**MEETING AGENDA OF THE
PLANNING COMMISSION OF THE TOWN OF FRISCO
FRISCO TOWN HALL
1 MAIN STREET
FRISCO, COLORADO 80443
SEPTEMBER 17, 2026
5:00 PM**

Agenda Item #1: **Planning File No. MAJ-26-0003**: A sketch plan review of the Major Site Plan application for a proposed residential development consisting of eight (8) new townhomes. Location: 207 Granite Street / Lots 13-18 Block 8 Frisco Town Sub. Applicant: Robert Craig representing 207 Granite St LLC, owner.

PLANNING COMMISSION STAFF REPORT

AGENDA ITEM: **Planning File No. MAJ-26-0003:** A sketch plan review of the Major Site Plan application for a proposed residential development consisting of eight (8) new townhomes.

Proposed and existing non-vehicular pathways

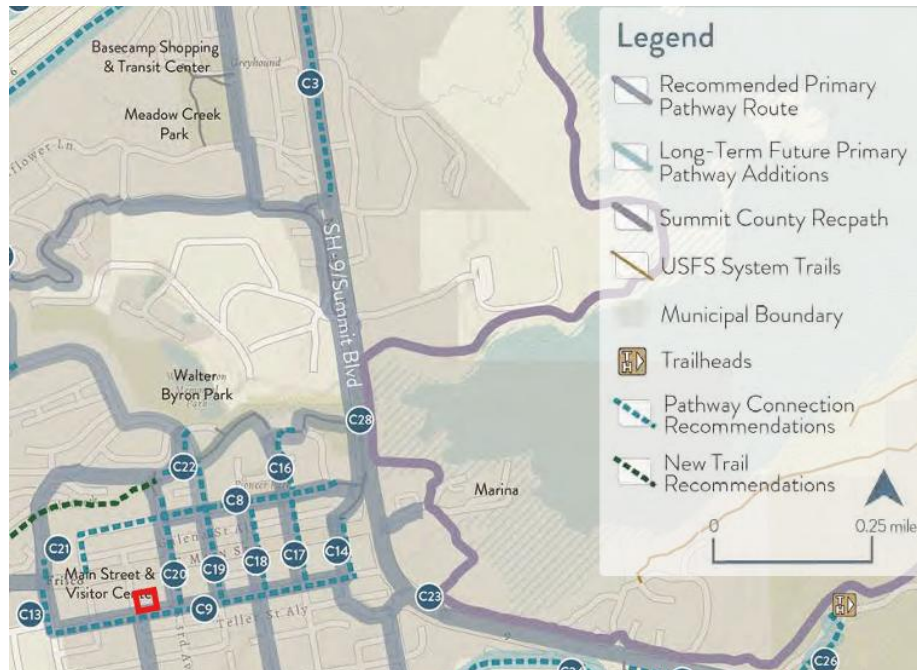
For units along Granite Street and S. 2nd Avenue, the application materials show walkways connecting each unit to the nearest public street. The units along the alley side show a sidewalk connecting to the dumpster enclosure and out to the sidewalk along S. 2nd Ave. An additional walkway connects the internal garage areas to the dumpster enclosure. These walkways must be paved.

Recommendations from the 2023 Frisco Trails and Pathways Master Plan

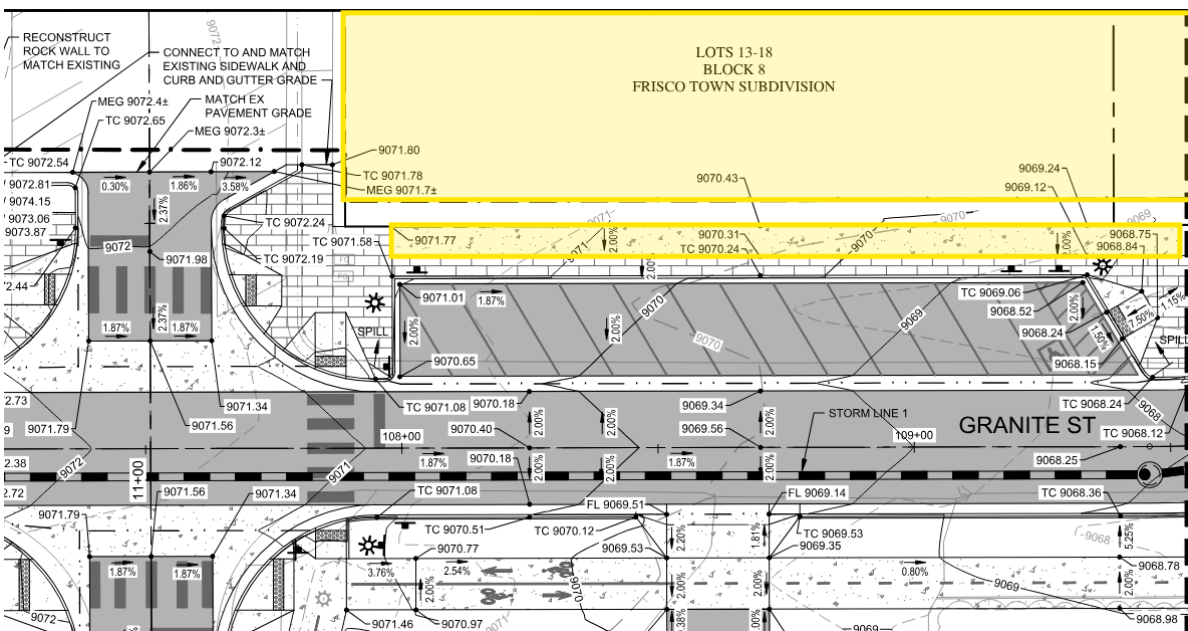
The 2023 Frisco Trails and Pathways Master Plan shows a separated multi-use path along Granite Street adjacent to the proposed development as part of the Downtown Complete Streets Plan. The latest plans for Complete Streets, provided by the contracted Town Engineer, show a 6-foot sidewalk with diagonal parking adjacent to the subject property. Staff strongly recommend that the applicant review the planned design for Granite Street and add the proposed sidewalk connection at a minimum for improved pedestrian safety for the development rather than connecting the walkways for each unit on this side to the roadway on Granite Street. The Town cannot require the applicant to build the sidewalk at this time.

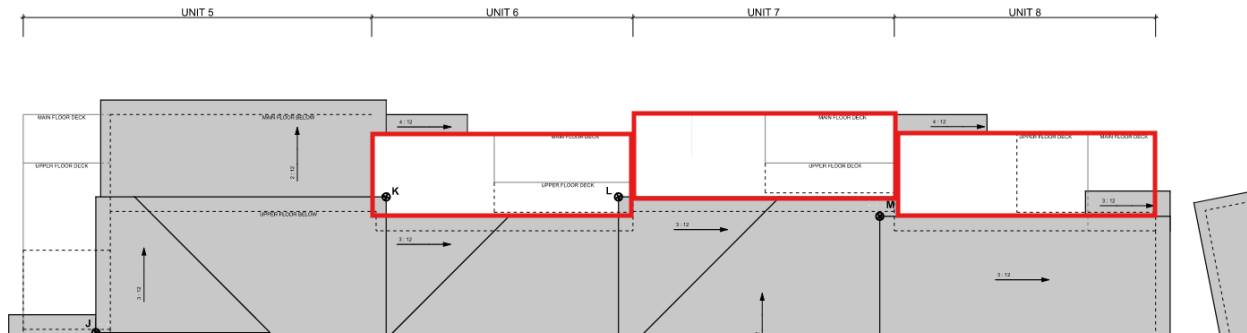
The proposed parking plan features stacked tandem spaces inside garages for all units. The Planning Commission must determine if the tandem spaces in each of the garages meet the intent of the parking regulations. Staff suggests that the design meets criteria (ii) and (iv).

Snow storage plan for alley-facing units

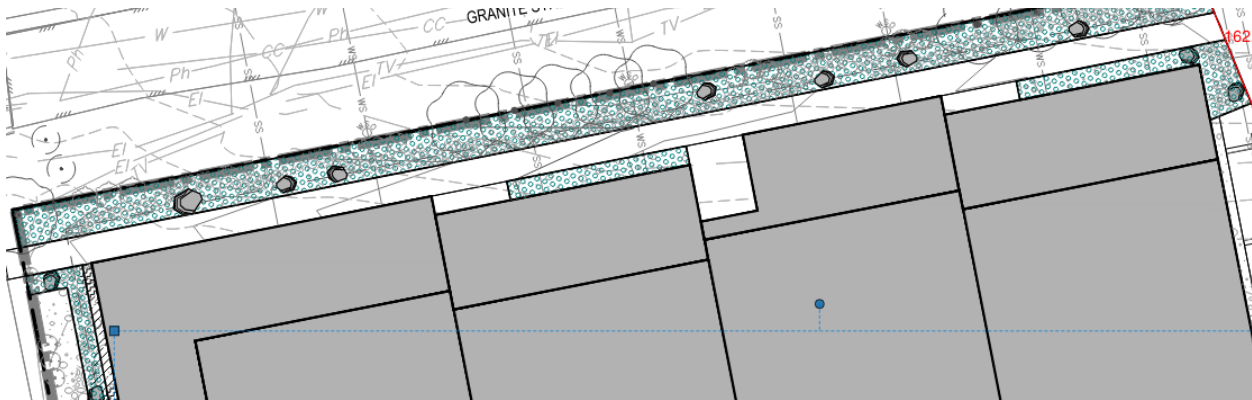
The application materials show that the total snow storage meets the 25% quantity requirement, but additional information will need to be provided at final site plan submittal measuring each applicable surface area individually and the snow storage quantity adjacent to each area. Staff does not have concerns about the 8-foot width requirement. Snow storage also

must be provided for the uncovered portions of upper level decks. The applicant will need to clarify how the snow from uncovered decks on the alley side will not be deposited on the pedestrian walkway on that side:

Alley-facing uncovered decks

North Building, North Elevation – facing alley. Yellow outlines show areas providing relief from duplication of units.

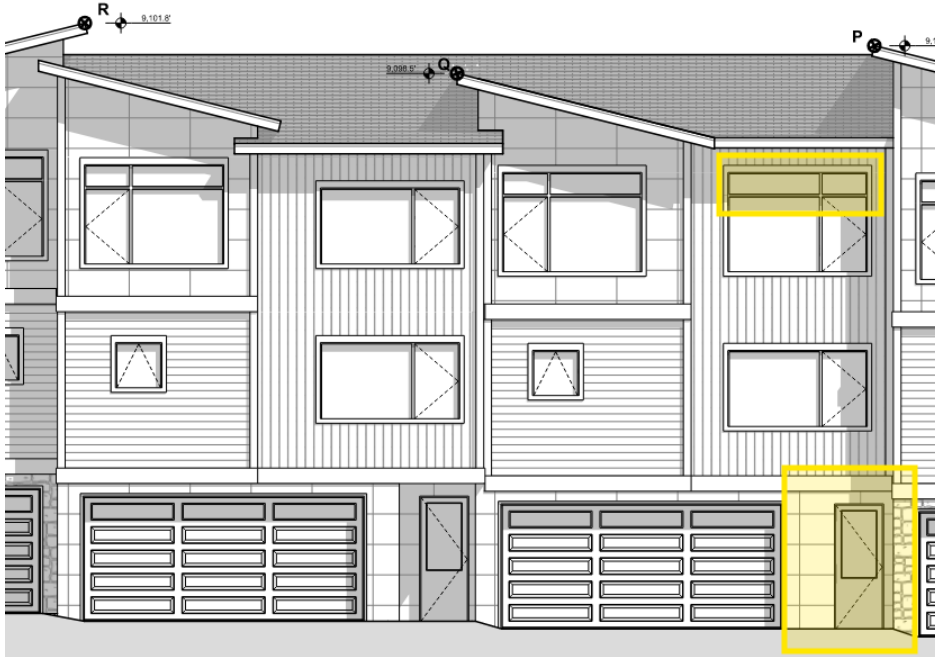
The application materials show two new buildings that are similar to one another but not duplicative. Within each building, some units are similar but none are exact duplicates. The most similar unit facades are facing the internal driveway, not facing streets. Variation is provided with siding materials, windows, entrance locations, roof planes, and more. Examples of differences between two similar units on the north building are shown below. The south building has similar duplication on the middle two units.

Staff requests that the Planning Commission provide feedback to the applicant on the building design variety.

Building areas with potential snow shedding concerns

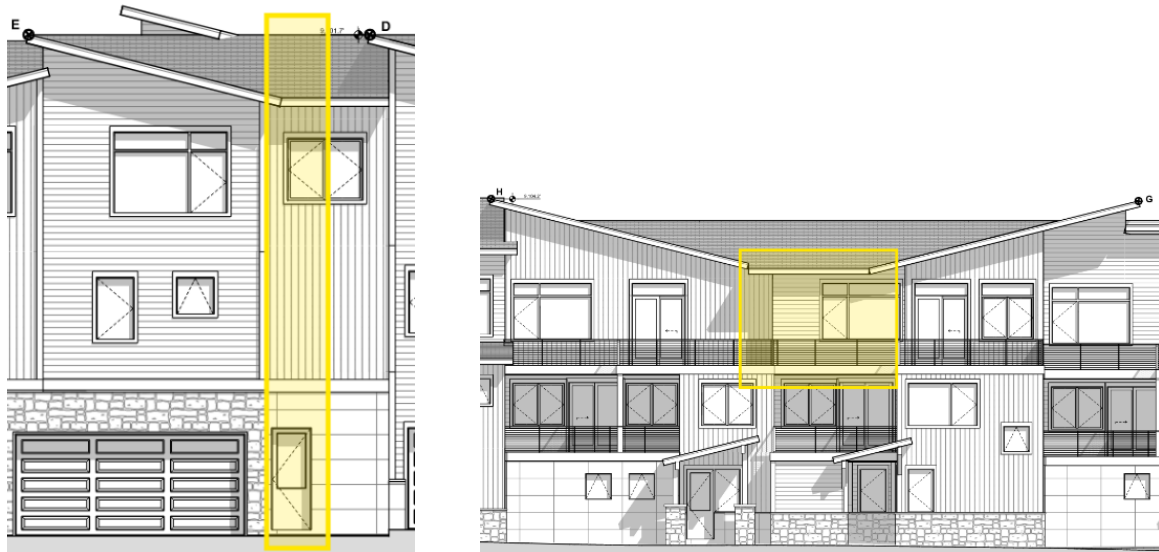
All roof pitches are proposed to be pitched at 3:12, except for some lower-level roof elements that are 2:12 or 4:12. All roof elements are proposed to have shingles, color “Weathered Wood,” meeting the requirements. There appears to be potential snow shedding issues as identified in images pasted below which should be addressed at time of full site plan application submittal.

1 NORTH BLDG BULK PLANE ENCROACHMENTS
(A-11)

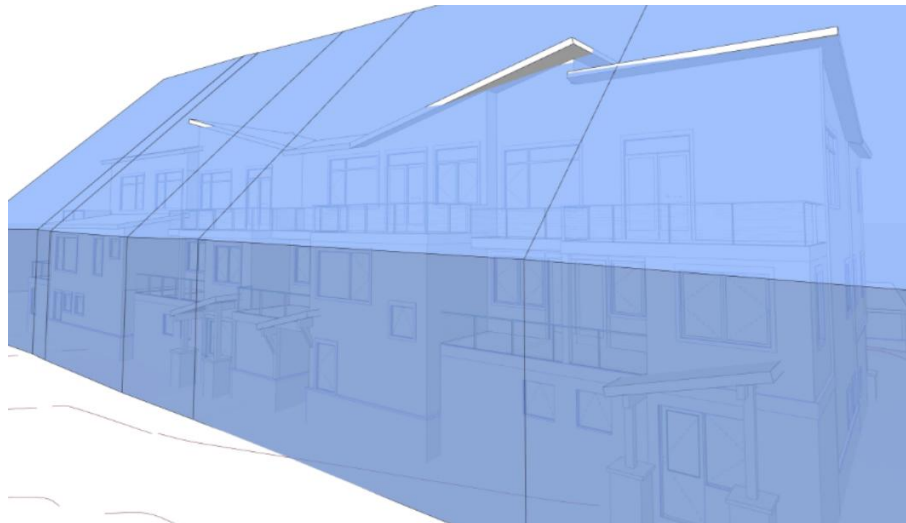
The application materials show bulk plane renderings and calculate 200 cubic feet of total bulk plane encroachments. The bulk plane encroachments appear to be just for roof eaves. Planning Commission should comment on whether the proposed bulk plane encroachments provide substantial architectural relief.
